# Service Technical Information

MODEL NO.	MD Mechanism 3ZG-5
SUBJECT	Warnings when replacing SHAFT, PU GUIDE A and HLDR, PU GUIDE A

REF.No. :G – A0 – 010 – E0

DATE :26. APR. 2000

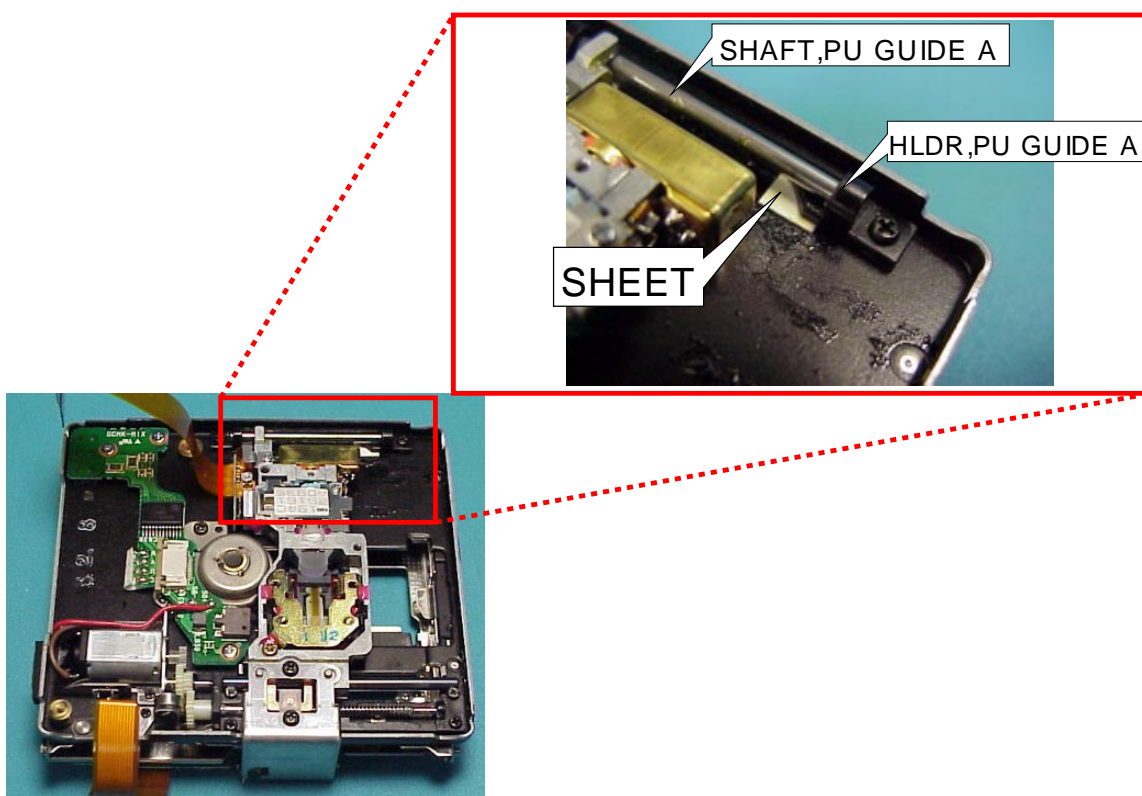
SHAFT, PU GUIDE A, and HLDR, PU GUIDE A are being modified.

To maintain compatibility, please confirm whether or not the sheet in the following diagram is present.

When the sheet is present:

When the sheet is not present:

Remove the sheet and replace at the same time SHAFT, PU GUIDE A, and HLDR, PU GUIDE A with the parts listed in the part codes below.

SHAFT, PU GUIDE A, and HLDR, PU GUIDE A, respectively, can be replaced individually. However, upon replacement, use the part numbers listed in the part codes below.
